**Other Regulations – Regulation No. 119 (Cornering lamps)**

## **Proposal for Supplement 5 to the 01 series of amendments to Regulation No. 119 (Cornering lamps)**

### **Submitted by the expert from Poland\***

Figure 3

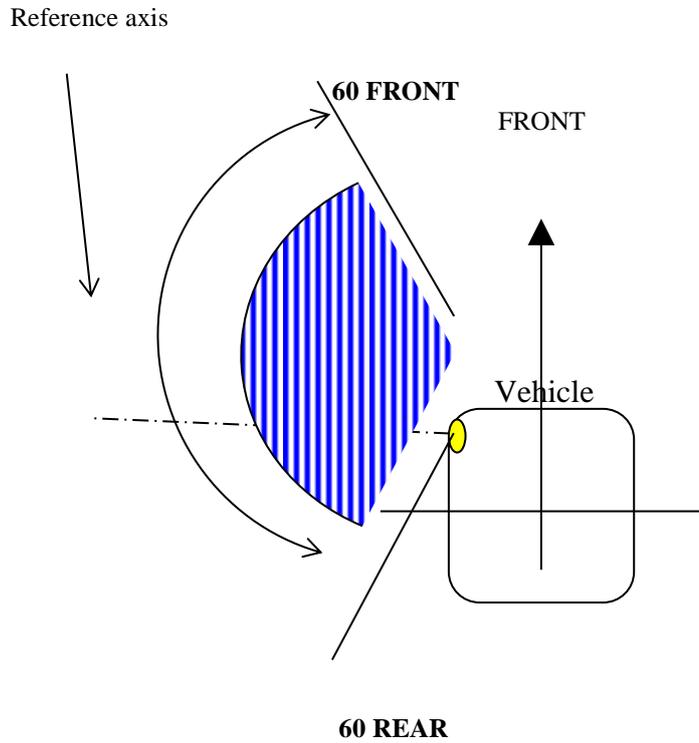
*Annex 1*, amend to read:

2.2.1. Field of geometric visibility

2.2.1.1. The directions  $H = 0^\circ$  and  $V = 0^\circ$  correspond to the axis of reference. On the vehicle, they are horizontal, perpendicular to the median longitudinal plane of the vehicle and oriented to the left side of vehicle. They pass through the centre of reference. The values shown in the table give the minimum intensities in cd for the various directions of measurement."
